CITY OF ALBUQUERQUE

April 28, 2021

RE: **Lot 6 Block 6 Unit 18 SAD 228
6608 Kimmick Rd. NW
Volcano Cliffs Subdivision
Grading and Drainage Plan
Engineers Stamp Date 4/26/2021 (D10D003M6)**

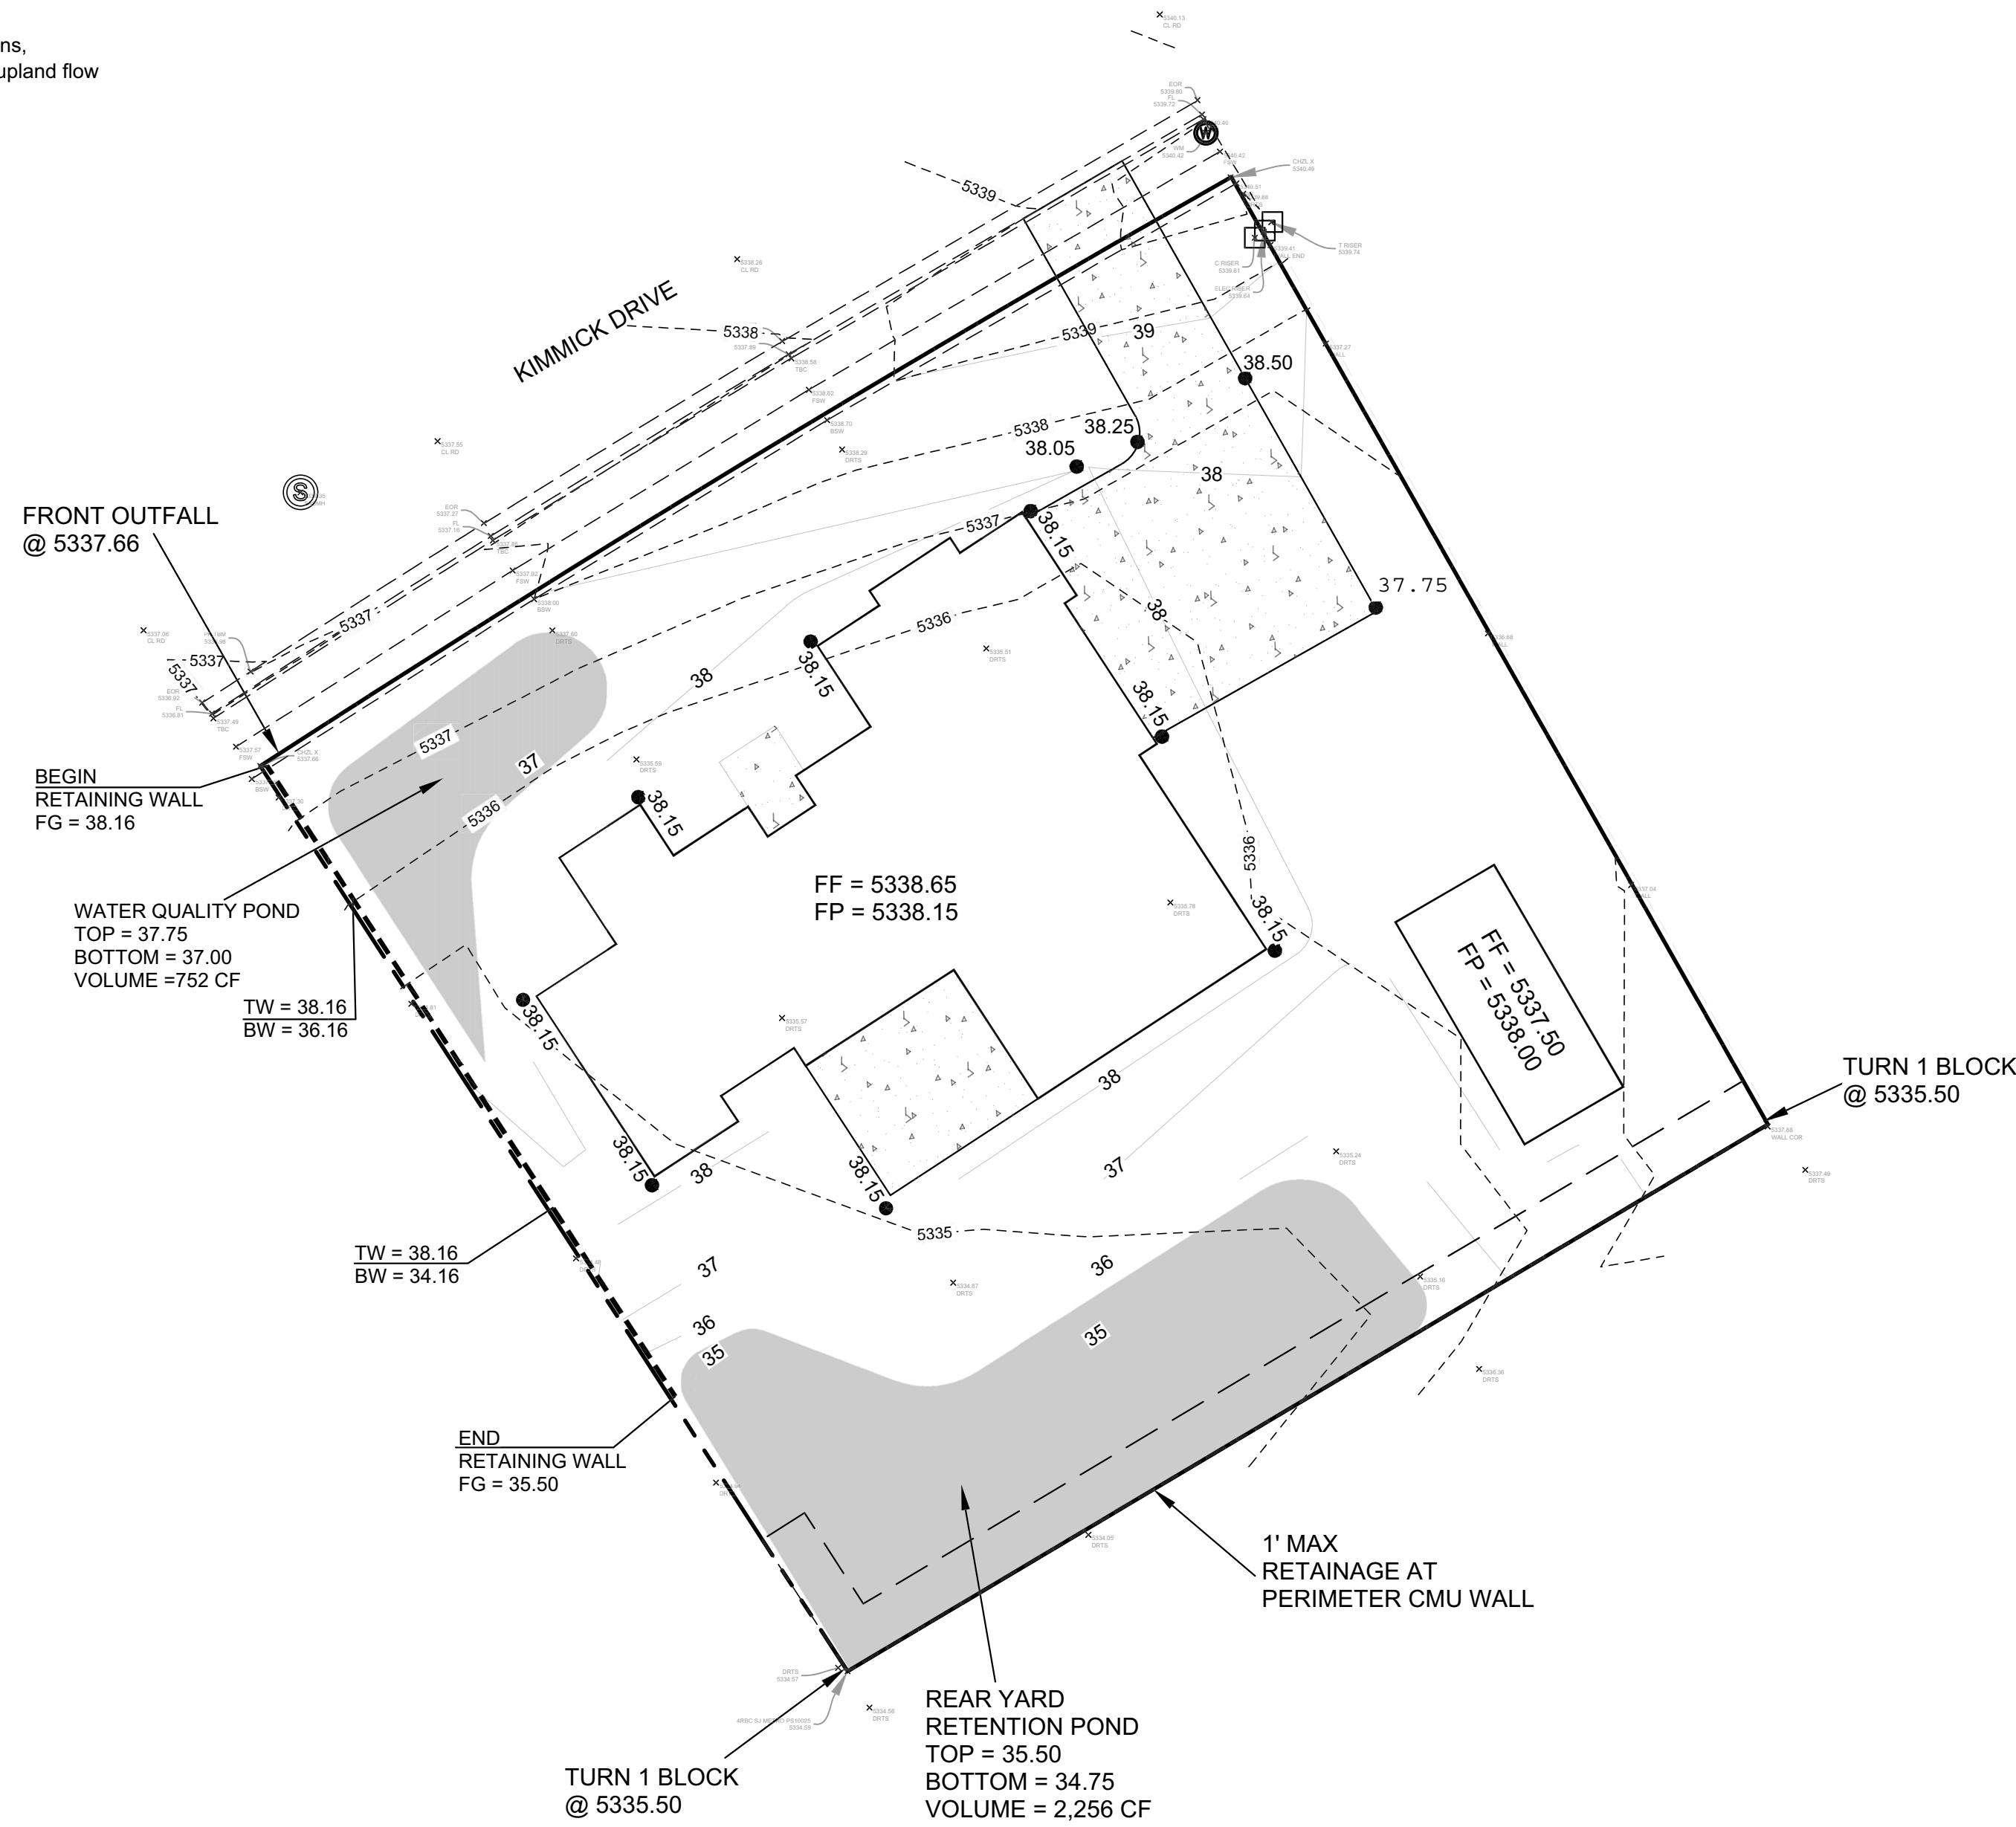
Based upon the information provided in your submittal received 4/28/2021, this plan is approved for Grading Permit.

Prior to Building permit approval a Pad Certification will be required, provided by the Engineer or a registered Land Surveyor.

Advise the owner contractor not to use dirt as a ramp to climb the curb, use lumber or crusher fines for this purpose.

Reiterate to the Owner/Contractor that a separate permit for a garden/retaining wall must be obtained with the approved G&D plan and Pad Certification. Also, if a swimming pool is to be placed the grading and drainage plan will change and will need to be resubmitted.

Prior to Certificate of Occupancy release, Engineer Certification per the DPM checklist is required.
